PLANNING COMMISSION MEETING AGENDA

APRIL 16, 2024

LSDP: Vin Hotel

Vin Hotel

Site Plan Detail

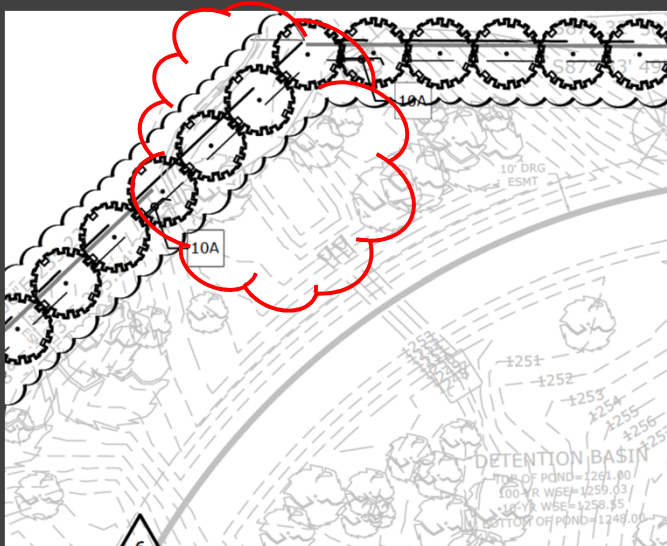
Applicant must show a gap in the wall, where the proposed masonry wall intersects existing drainage infrastructure, in the northwestern corner of the subject property.

This will be reviewed and approved at the time of construction plan review by Engineering staff.

Tree Preservation Plan

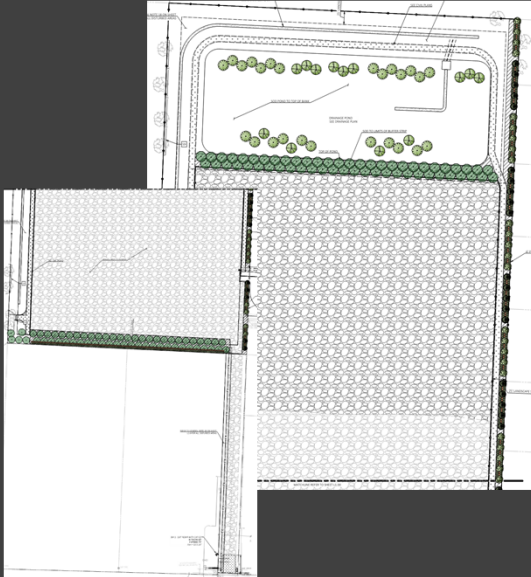
- Dated 4/2/2024
- Red dots signify significant trees cleared (8" or greater in caliper) – 143
Significant trees removed from the site
- Green dots signify insignificant trees cleared (Less than 8" in caliper)
- Trees with X's indicate significant trees to be cleared as part of the proposed LSDP
- Tree outline with no X indicate preserved trees., per proposed LSDP
- 5:1 tree mitigation ratio(applied to trees cleared without permitting or cleared outside of development area) would require the developer to plant 715 new trees. Standard 1:5 mitigation ratio applied to trees removed because of development. In this instance, 14 standard mitigation trees would be required, totaling **729 mitigation trees** for the entire site. This number does not include required landscaping provisions, based off of total development area.

- Applicant is not meeting required landscaping counts for this development, as proposed.
 - 715 trees (5:1 ratio for indiscriminate clearing; 143 trees cleared without permitting)
 - 14 trees (1:5 ratio – standard mitigation rate; 68 proposed significant trees removed per this LSDP)
 - 222 trees (Standard landscaping requirement; based on development area (888,581 sq.ft. or 20.39 acres.))
- **951 trees REQUIRED, per LSDP**
- Applicant is providing **216** total tree plantings; 666 shrubs with this submittal.
